Model	AD1	Volt/Hz	Date of Modification	Serial Number
Modified Article		No serial Number cut-in information		
Reason for Modification	Parts catalog correction

The following should be corrected. Please correct your part catalog.

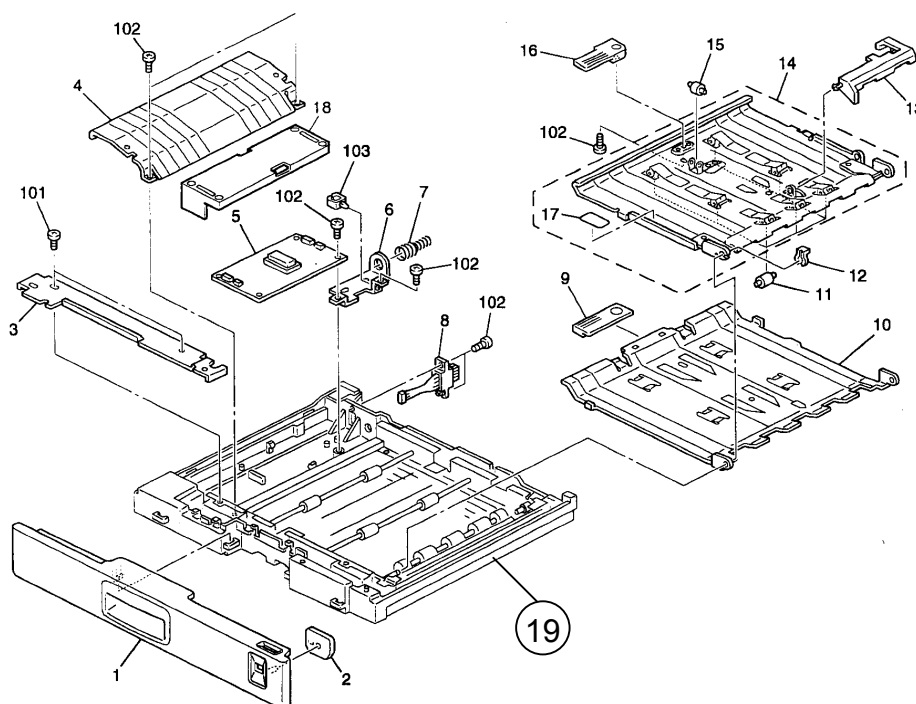
The following part number is missing. Please correct your part catalog.

Old part number	New part number	Description	Q'ty	Int	Page	Index	Note
	G6944701	Duplex Tray	1		19	19

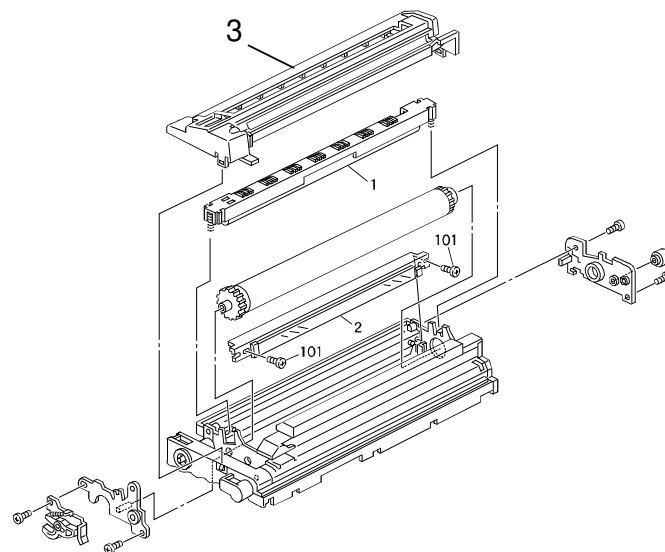
The durability of the cleaning blade holder has been increased to improve its resistance to high-temperature conditions, minimizing any noise generated in this area.

In accordance with this change, the PCU upper cover has also been changed to allow the new cleaning blade holder to be installed.

Note: The new cleaning blade and upper cover must be replaced **together as a set**
